DRAWING NO. D212-664-141	TITLE XTUBE ASSY (205/212/412 HI FWD)	REV. D	DART AEROSPACE LTD ENGINEERING ORDER		D.E.O. NO. D212-664-141-D-1	SHEET NO. SHEET 1 OF 2	SCALE NTS
DRAWN	CHECKED	MP	MFG. APPR.	RE 1	APPROVED	NA	DE APPR.
DATE 11.04.07	DATE 11.07.11		DATE 11.04.12		DATE 11/04/12		DATE 11.04.12

ADD AN INSPECTION WINDOW TO UNDERSIDE OF CROSSTUBE.

DRAWING NO. D212-664-141	TITLE CROSSTUBE ASS'Y (205 HI FWD)	REV. D	DART AEROSPACE LTD ENGINEERING ORDER		D.E.O. NO. D212-664-141-D-2	SHEET NO. SHEET 1 OF 1	SCALE NTS
DRAWN <i>UP</i>	CHECKED <i>ASS</i>	MFG. APPR. <i>AS</i>	APPROVED <i>MD</i>		DE APPR. <i>HH</i>		
DATE 11.07.15	DATE 11.07.20	DATE 11.07.21	DATE 11/07/21		DATE 11.07.21

REPLACE MAGNOBOND WITH PROSEAL.

**D212-664-141/-141B
ASSEMBLY DETAIL**

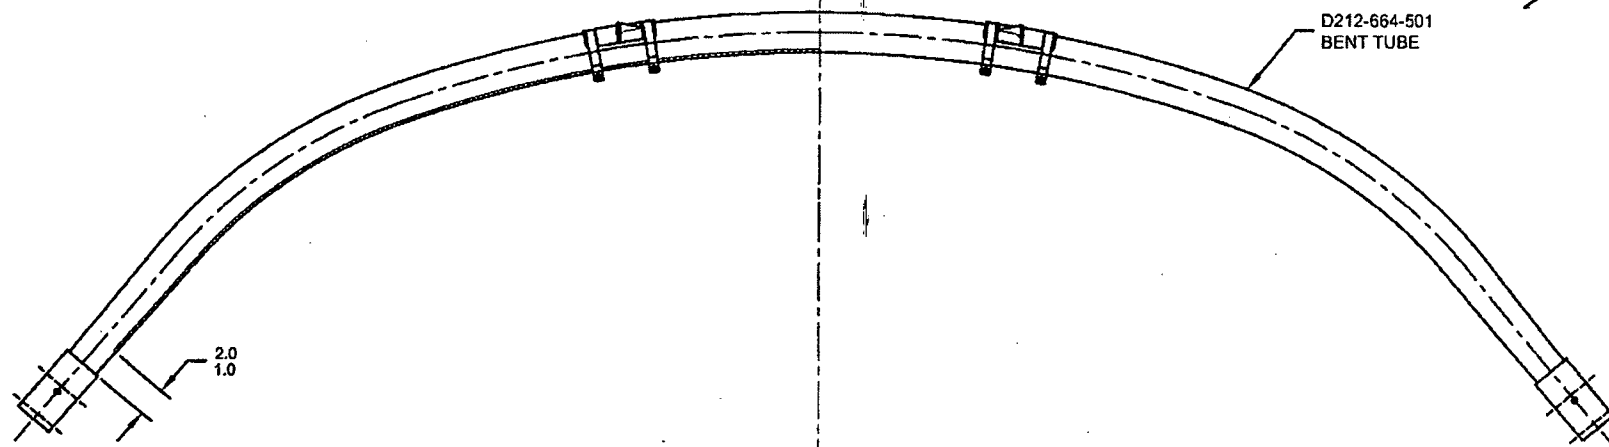
NOTES 2 OF SHEET 1 IS AMENDED AS FOLLOWS:

- 2) FINISH: CHEMICAL CONVERSION COAT PER DART QSI 005 4.1
PRIME INSIDE AND OUTSIDE PER DART QSI 005 4.2
MASK UNDERSIDE OF CROSSTUBE AS SHOWN (HATCHED AREA) AND
PAINT OUTSIDE PER DART QSI 005 4.2
REMOVE MASKING AND APPLY CLEAR COAT

MASK AREA PRIOR TO PAINTING,
REMOVE MASKING AFTER PAINT
AND APPLY CLEAR COAT
